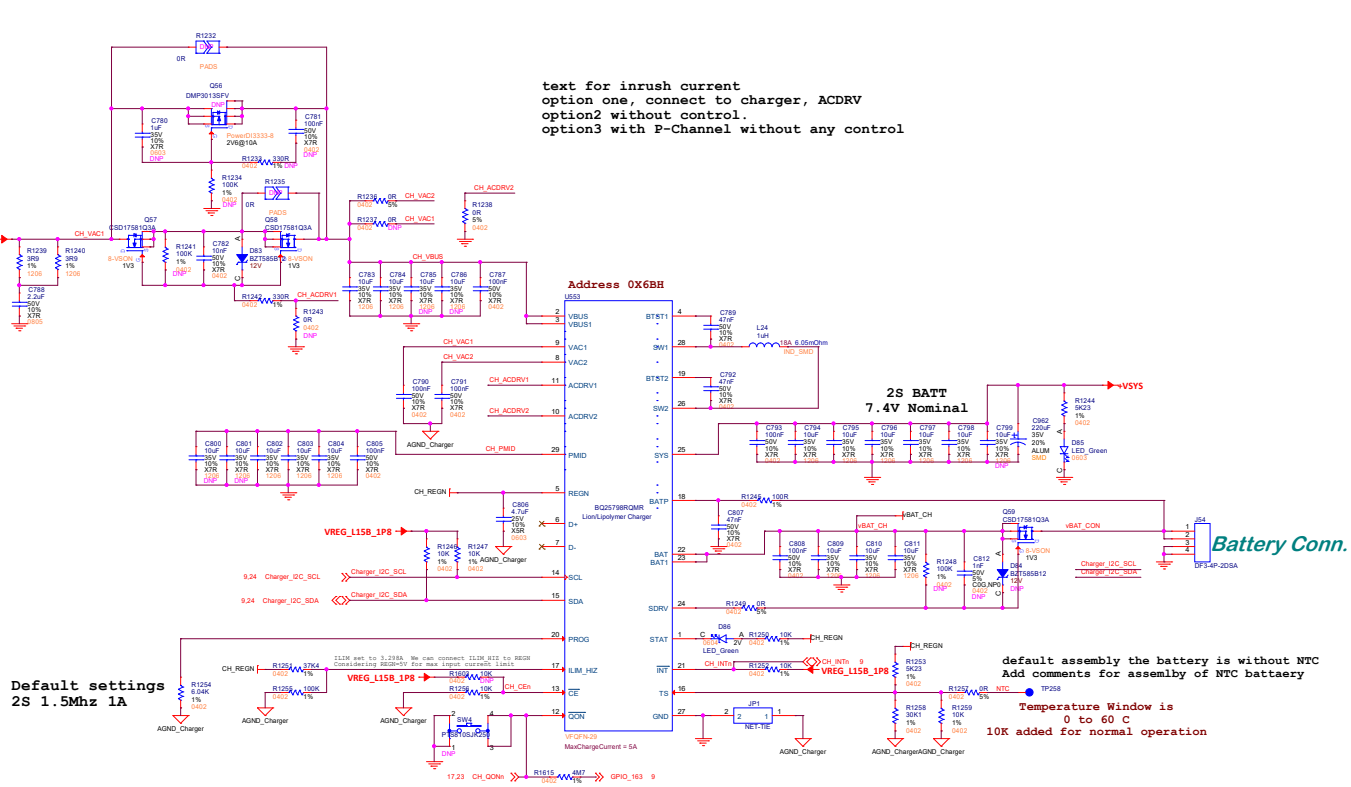
text for inrush current
option one, connect to charger, ACDRV
option2 without control.
option3 with P-Channel without any control

Minimum input for
charging is set to 1.7.9V
ACDET = 2.4V 817.9V

Default settings
2S 1.5Mhz 1A

default assembly the battery is without NTC
Add comments for assembly of NTC battaery
Temperature Window is
0 to 60 C
10K added for normal operation
